**TOWN OF GLASTONBURY**  
GL-2019-16  
**AIR CONDITIONING INSTALLATION AT**  
**GIDEON WELLES ELEMENTARY SCHOOL**  
ADDENDUM NO. 1  
December 20, 2018

**The following drawings, specifications and information are included in this addendum:**

DWG. NO.  
**M2.0**

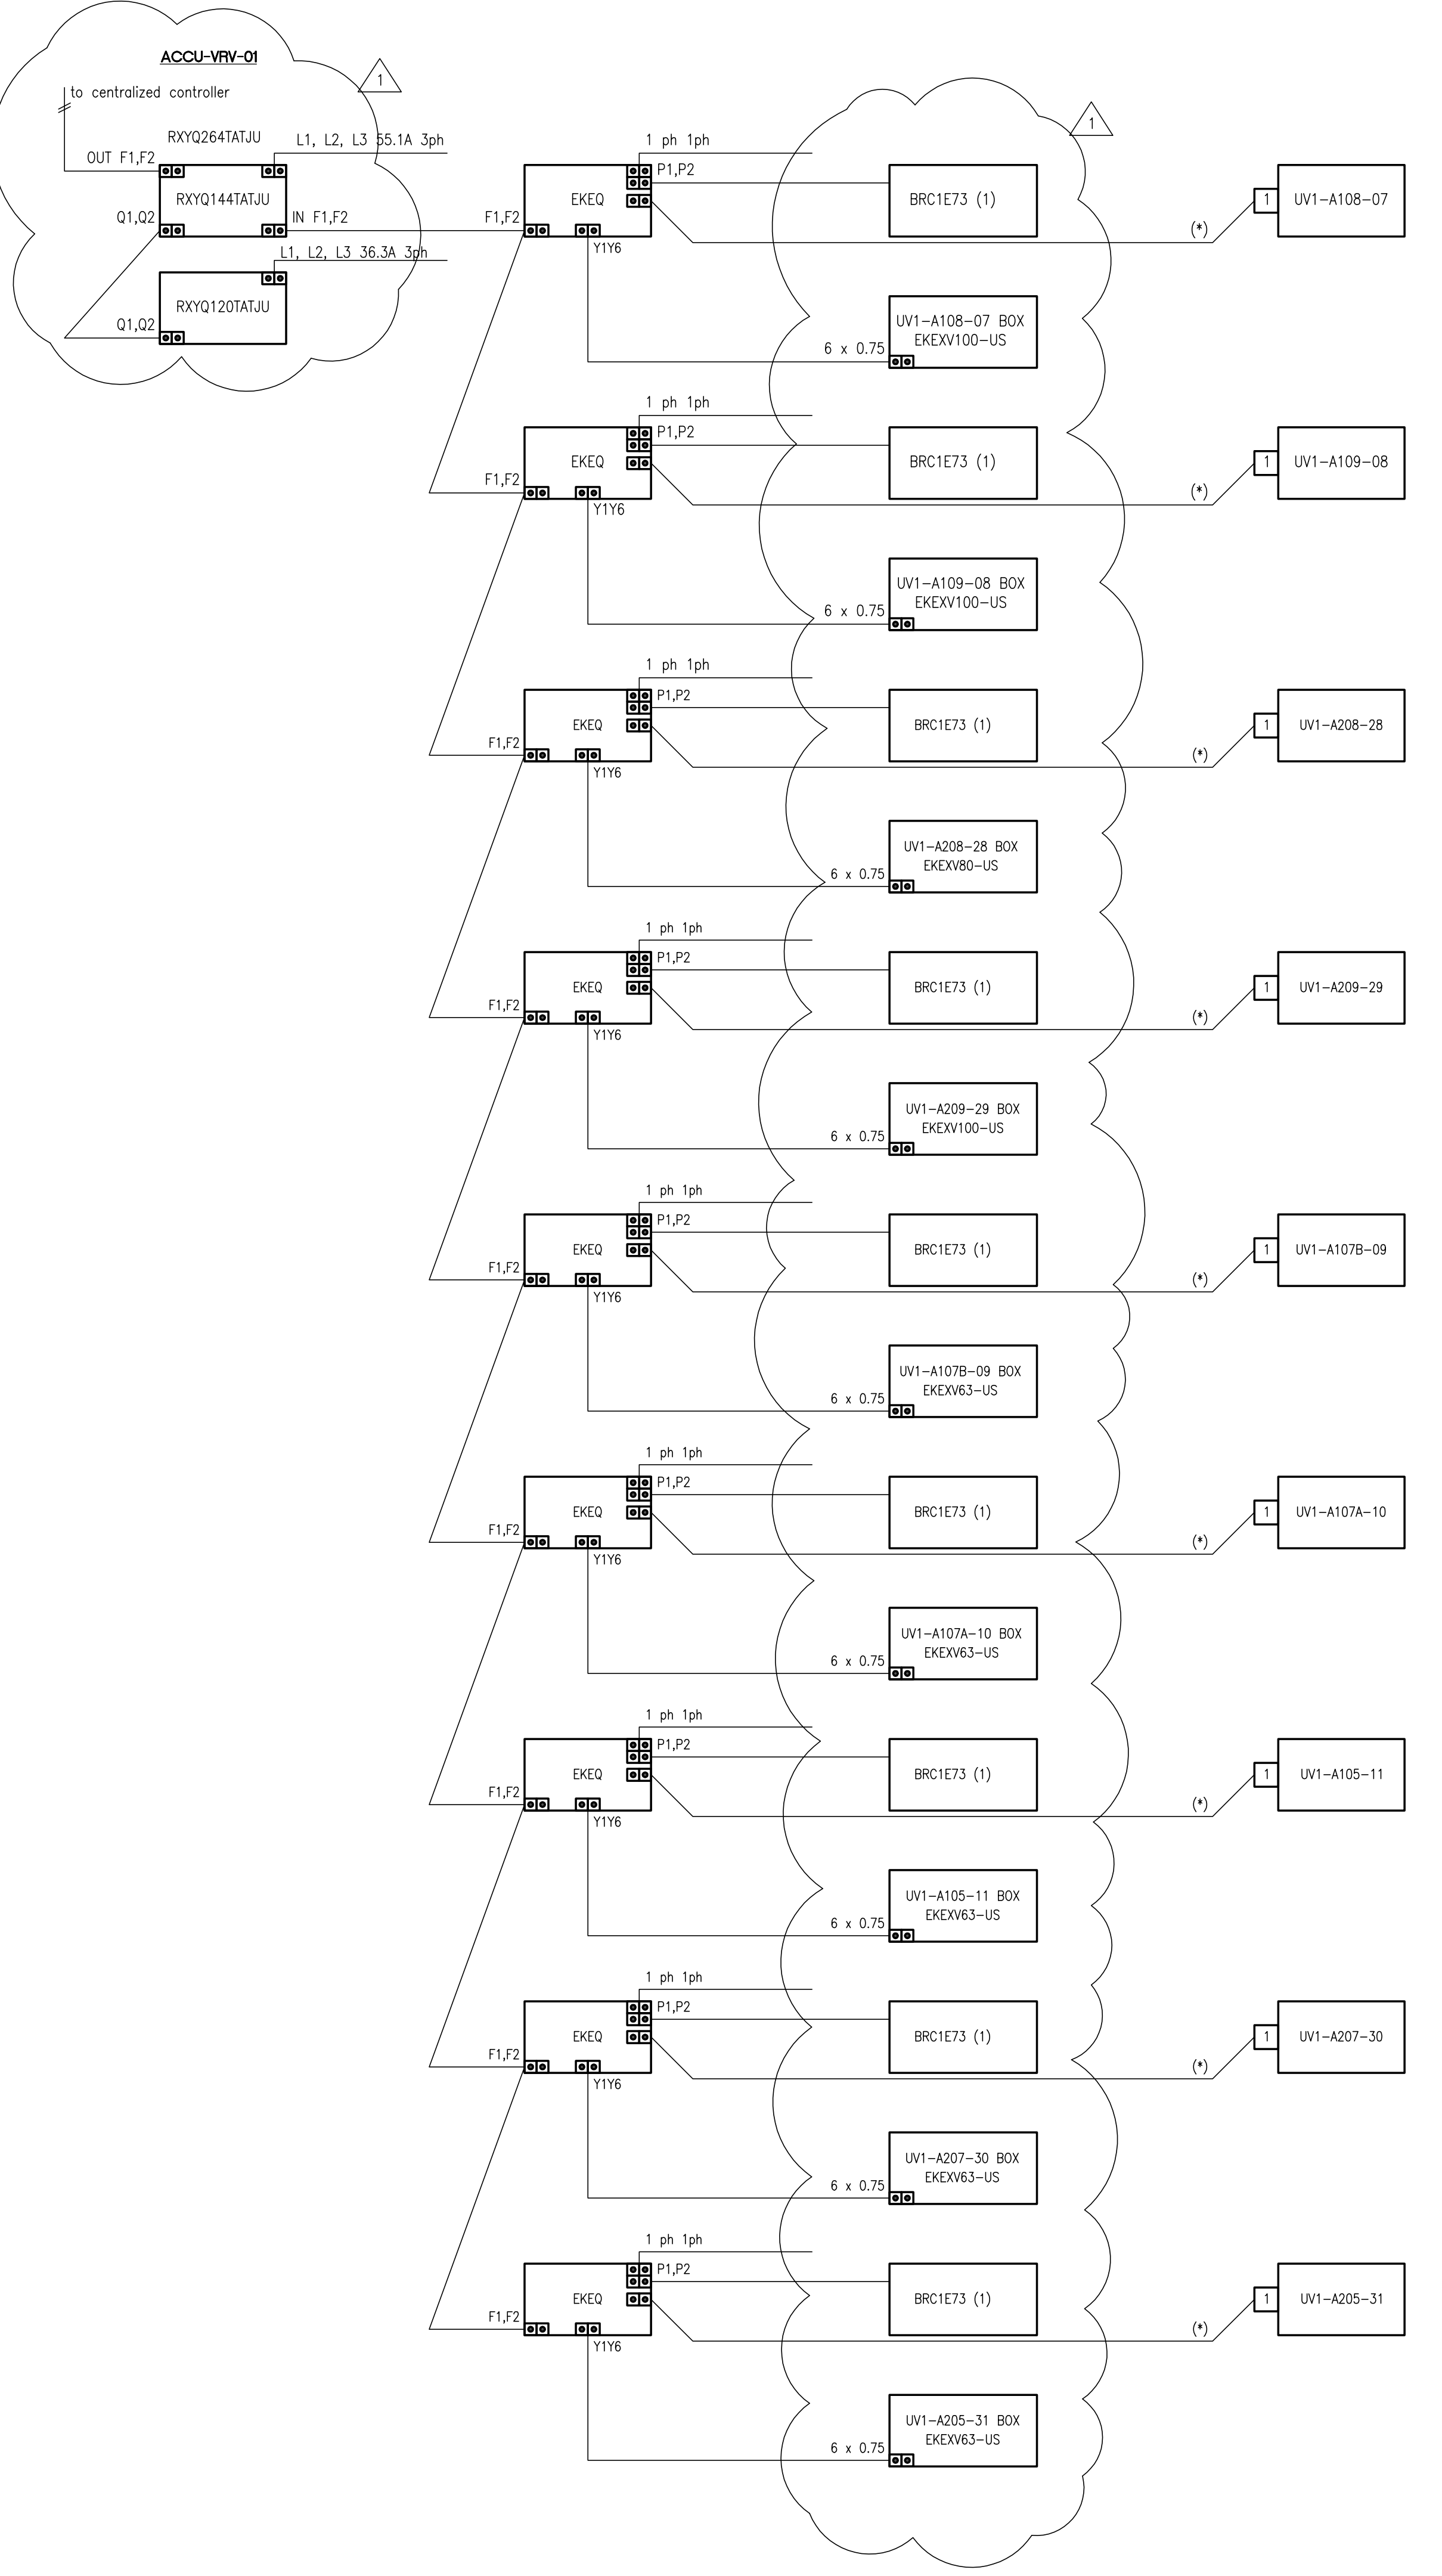
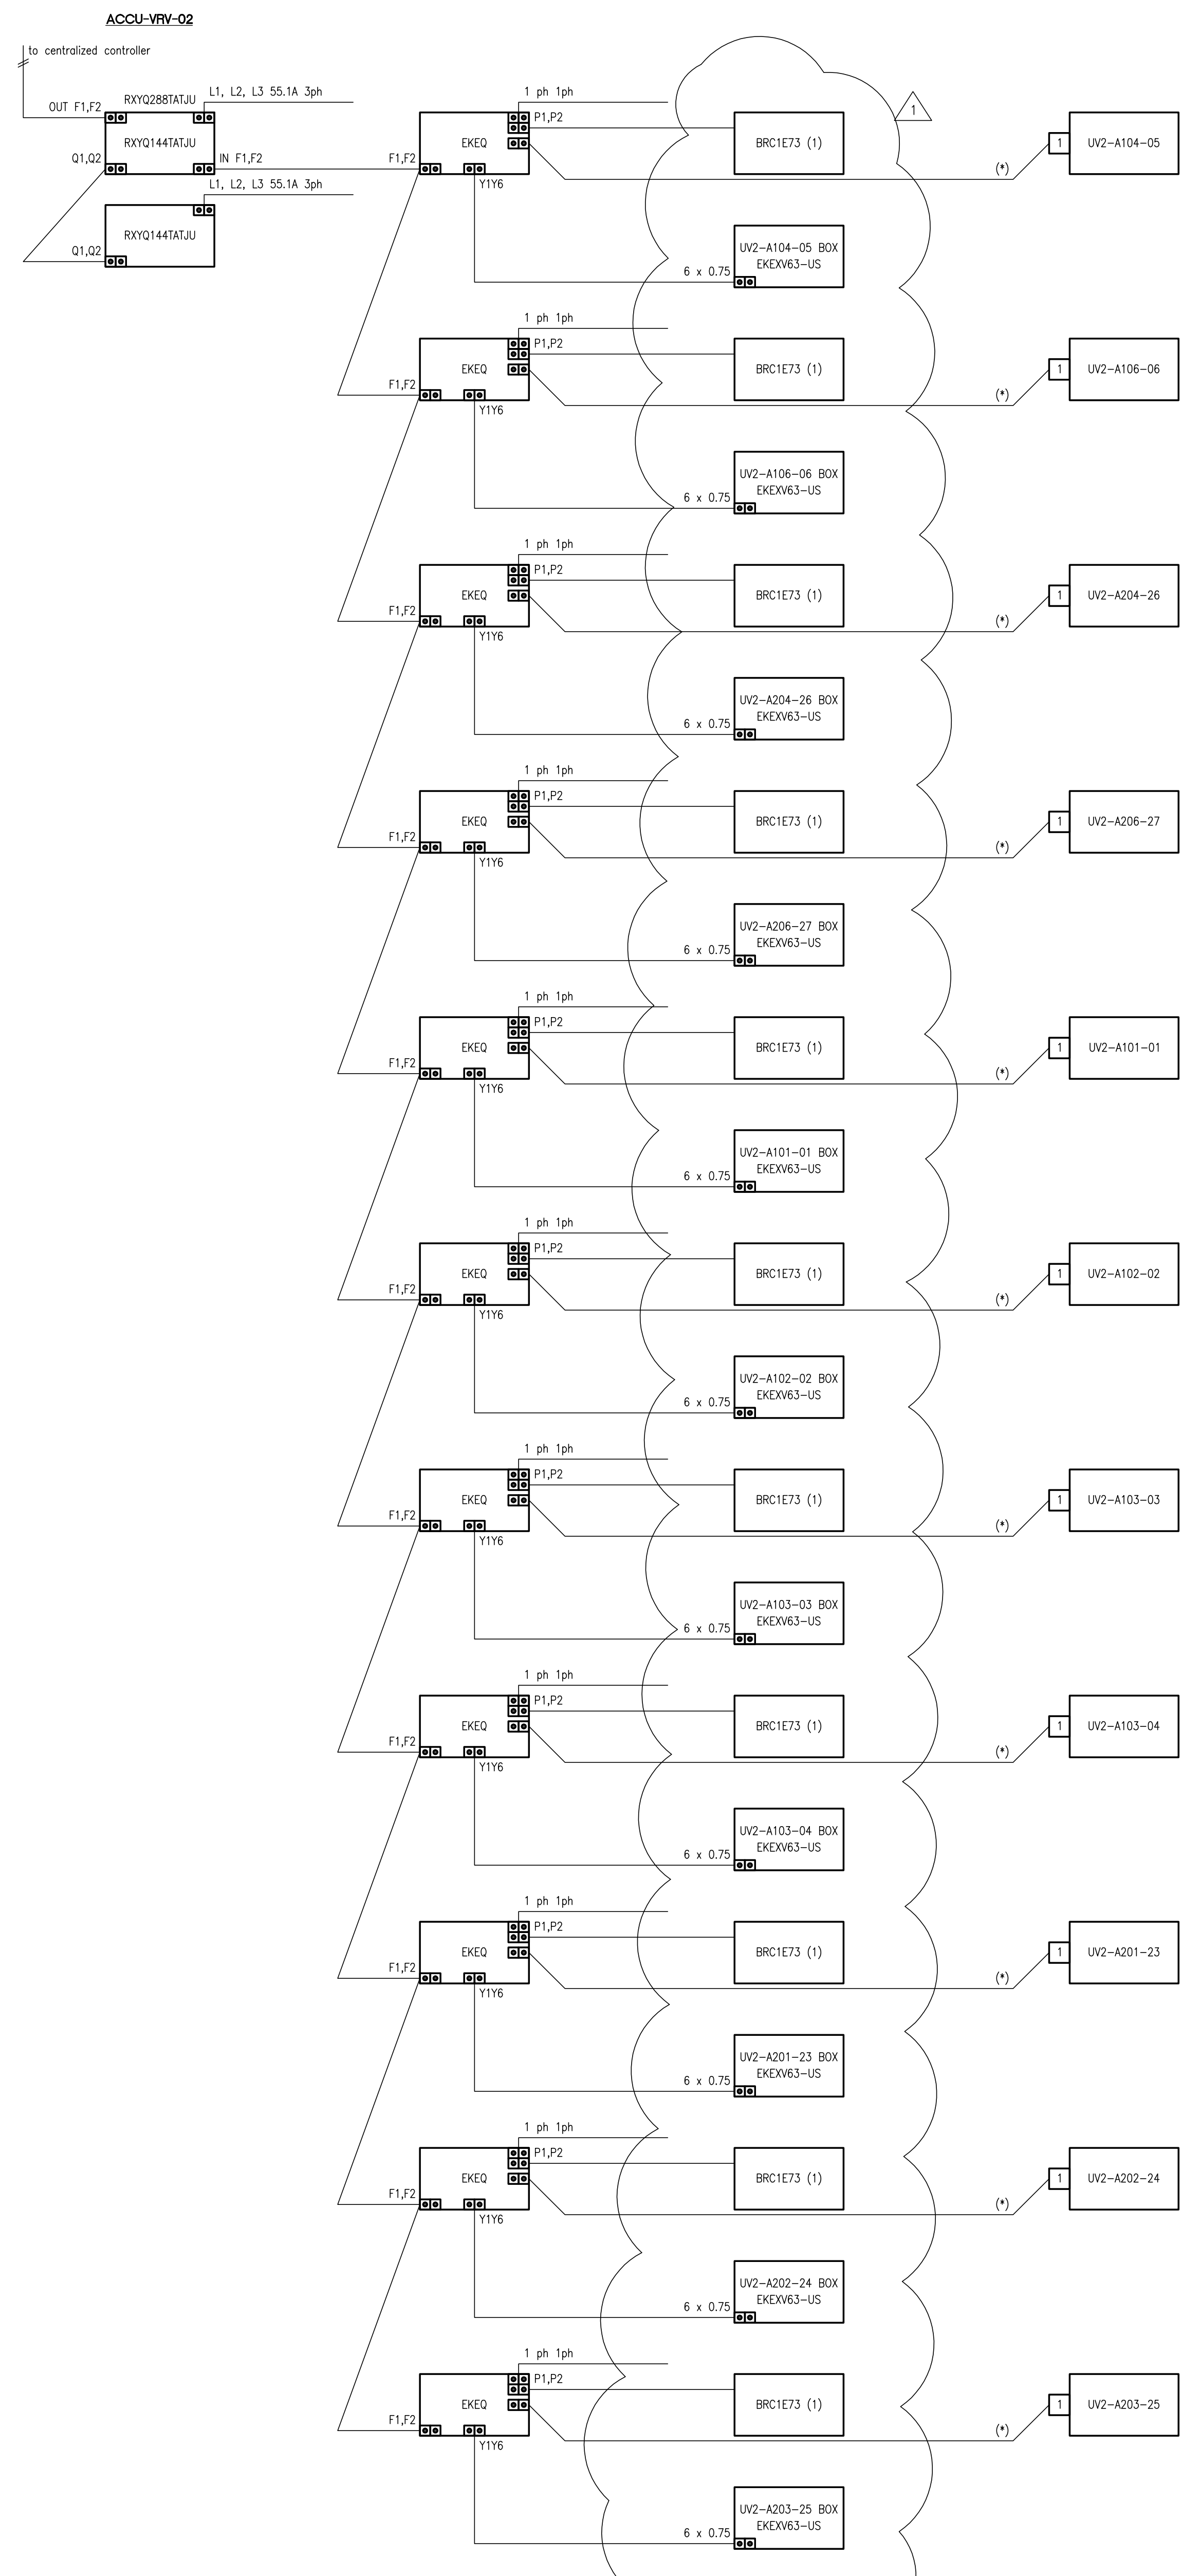
- h. Revise note 10 to read: wood panel to remain.
  - i. Revise note 11 to read: Tall storage cabinet to remain.
  - j. Revise note 15 to read: Existing D/X wall mounted indoor unit (EX-Dx-WIU) shall remain).
  - k. Revise note 17 to read: Existing Air-Cooled Condensing Unit (EX-ACCU) shall remain
  - l. Revise note 21 to read: Clean and disinfect existing Fin-tube radiation.
2. Replace drawing M0.2, dated 11/01/2018 with drawing M0.2 dated 12/17/2018.
  3. Replace drawing M2.0, dated 11/01/2018 with drawing M2.0 dated 12/17/2018.
  4. Replace drawing M3.1, dated 11/01/2018 with drawing M3.1 dated 12/17/2018.
  5. Replace drawing M3.2, dated 11/01/2018 with drawing M3.2 dated 12/17/2018.
